Niagara Scenic Parkway Project

Phase III: Findlay Drive, Niagara Falls NY to Center Street, Lewiston NY

Public Workshop #1

SUMMARY OF MEETING

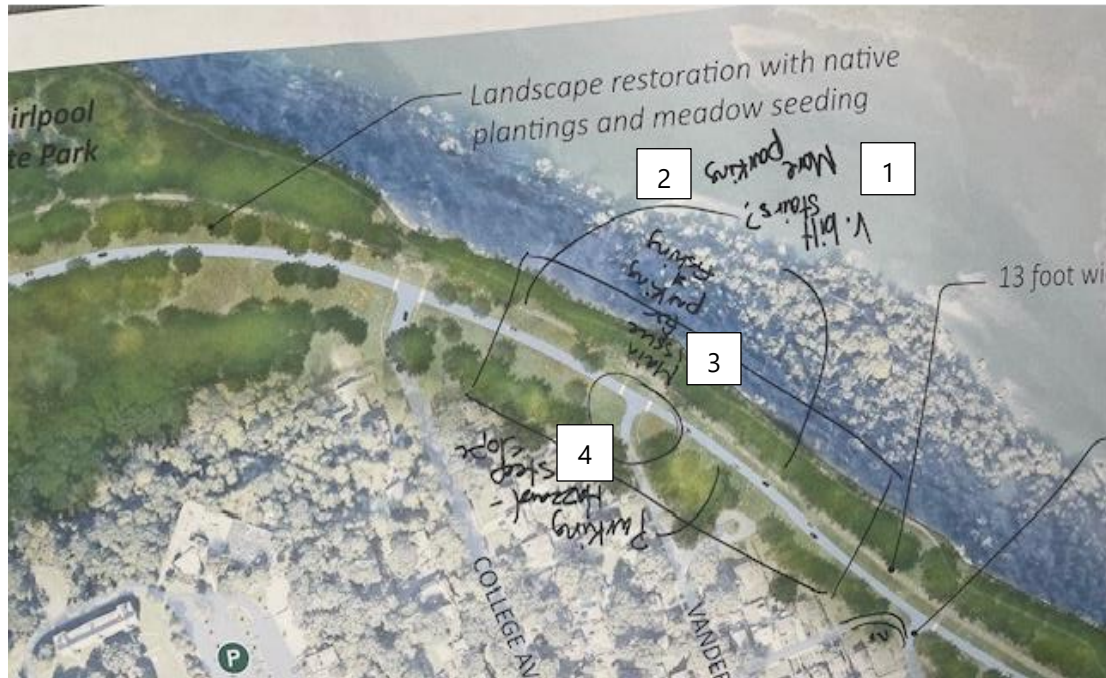
Area Specific comments are noted below:

1. V. Bilt stairs?
2. More parking.
3. Main issue for parking and fishing.
4. Parking hazard steep slope.
